UNITED STATES
DEPARTMENT OF THE INTERIOR
BUREAU OF LAND MANAGEMENTFORM APPROVED
OMB NO. 1004-0137
Expires: January 31, 2018**SUNDRY NOTICES AND REPORTS ON WELLS**
Do not use this form for proposals to drill or to re-enter an abandoned well. Use form 3160-3 (APD) for such proposals.5. Lease Serial No.
NMNM114968

☐ Oil Well ☒ Gas Well ☐ Other8. Well Name and No.
HH CE 35 2 FED 65

Changes to APD for Federal Well

Summary of Changes to Directional Plan Submission

WELL LOCATION AND ACREAGE DEDICATION PLAT

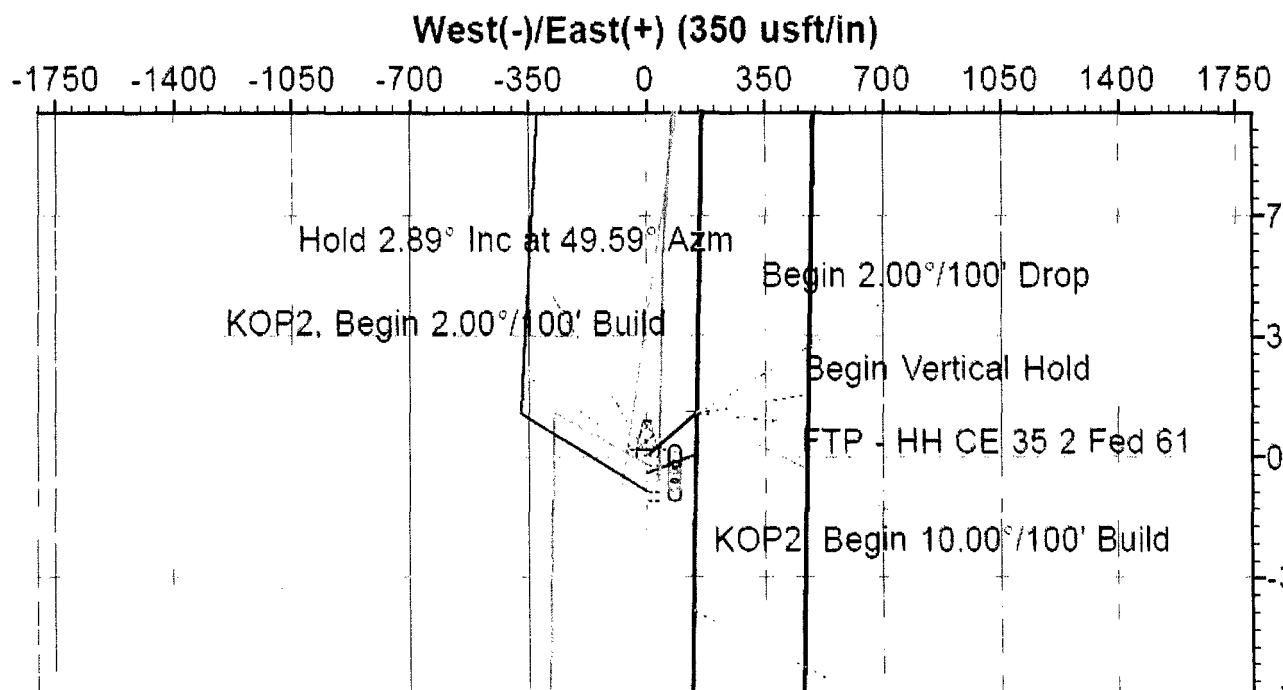
Chevron respectfully request a variance from the original directional plan, which will change the first/last points, and the bottom hole location. The original directional plan was bi-directional (N&S), but with the updated targets given by CVX geologist, the well path will be drilled to the South.

BHL from 280 N & 750 E to 180 S & 330 E
FTP from 330 N & 750 E to 2651 S & 330 E
LTP from 2640 S & 850 E to 330 S & 330 E

Project: Eddy County, NM (NAD27 NME)
Site: HH CE 35 02 Fed 006
Well: 5H
Wellbore: OH
Design: Plan 3 11-06-17
Rig:

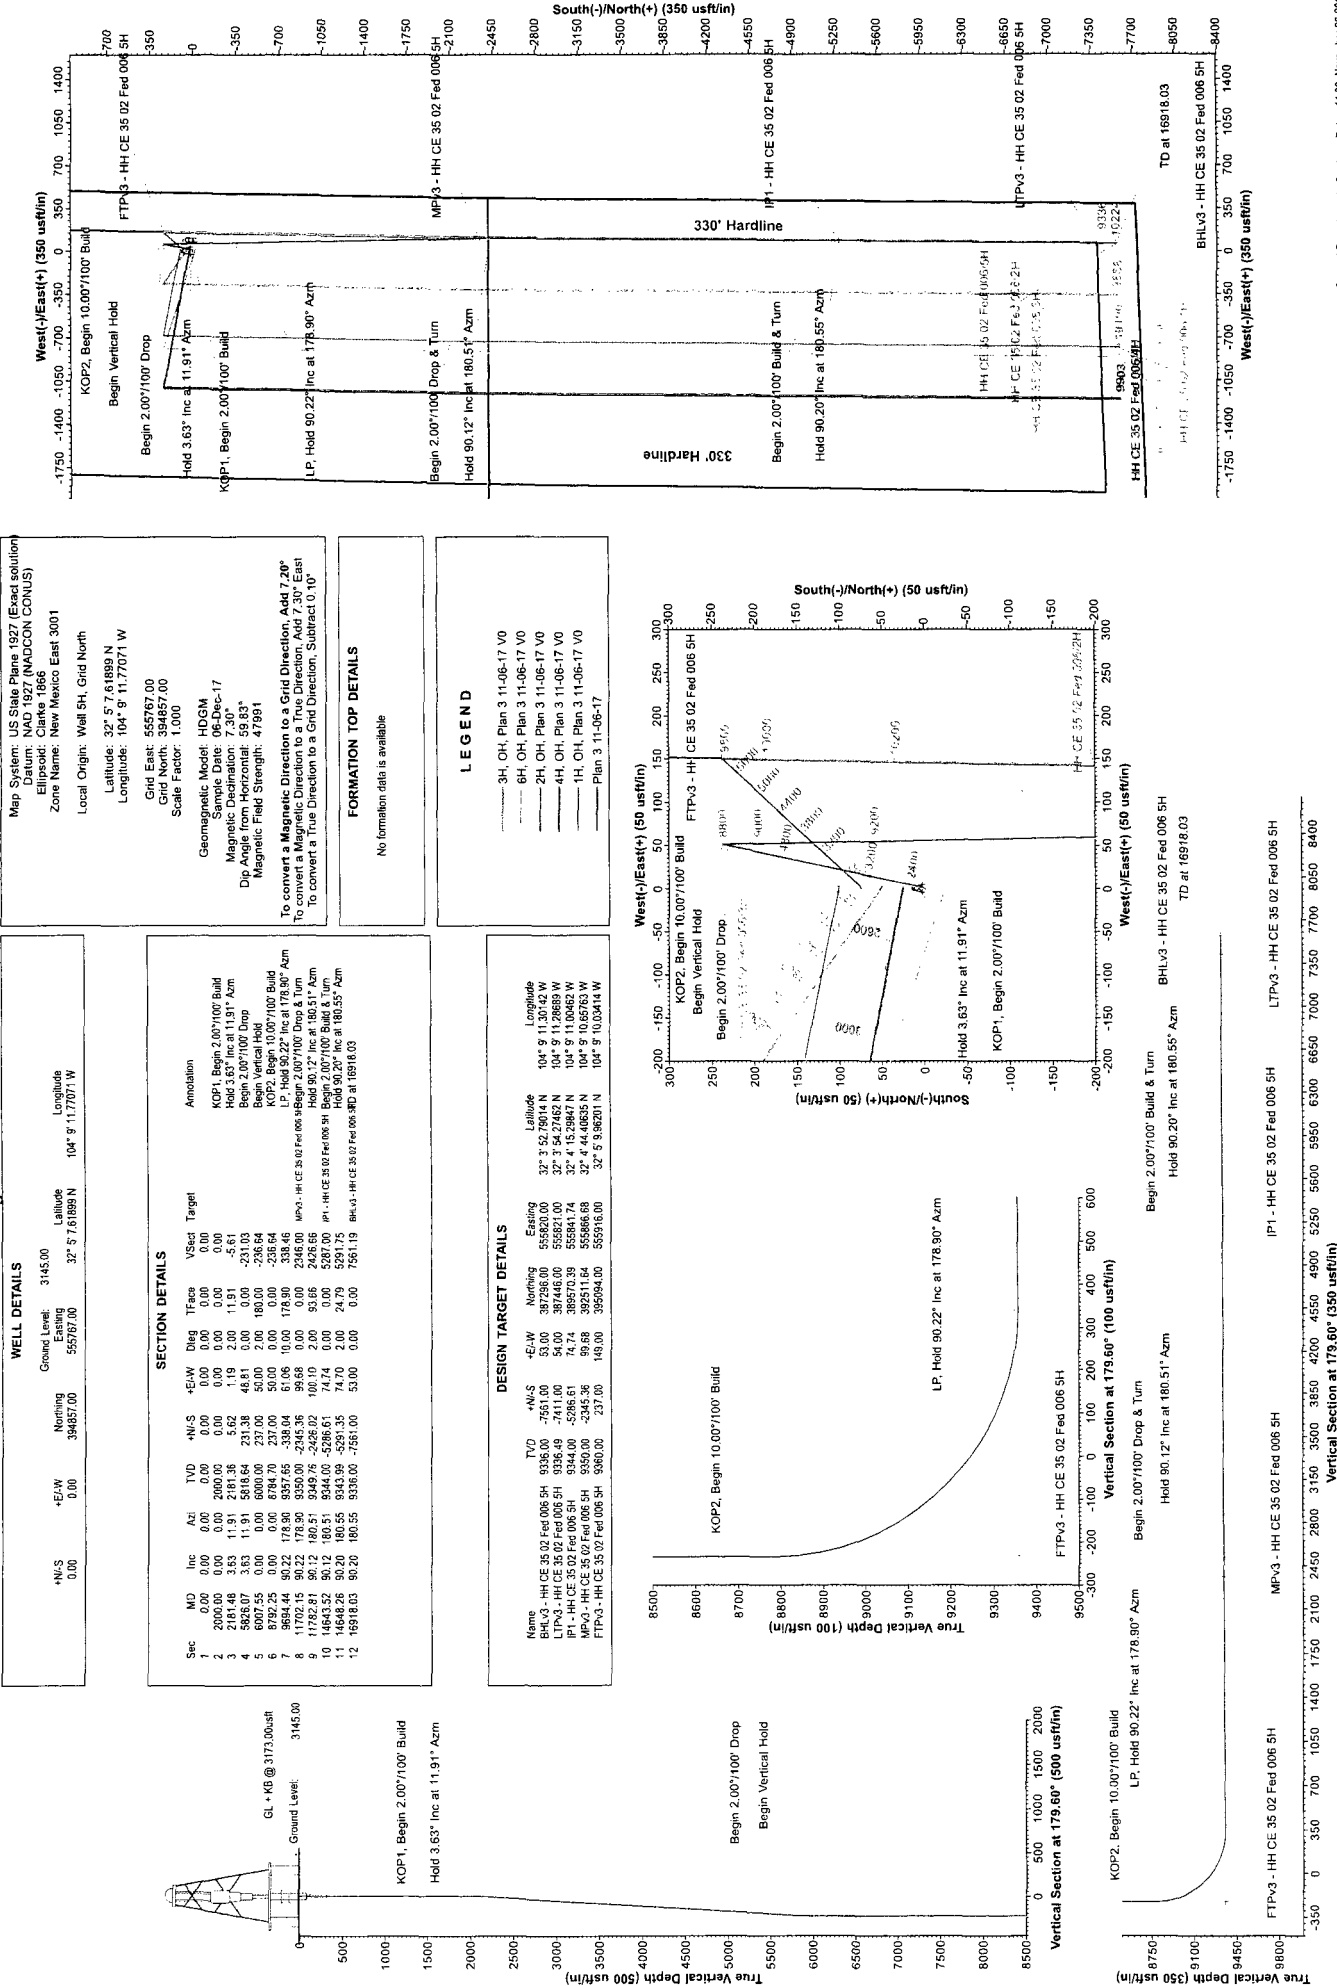
Chevron respectfully request a variance from the original directional plan, which will change the first take points/last take points.

Summary: The original directional plan was bi-directional (north & south), but with the updated targets given by Chevron geologist, the well path will be drilled to the south.

Chevron respectfully request a variance from the original directional plan, to drill all six wells to the south.
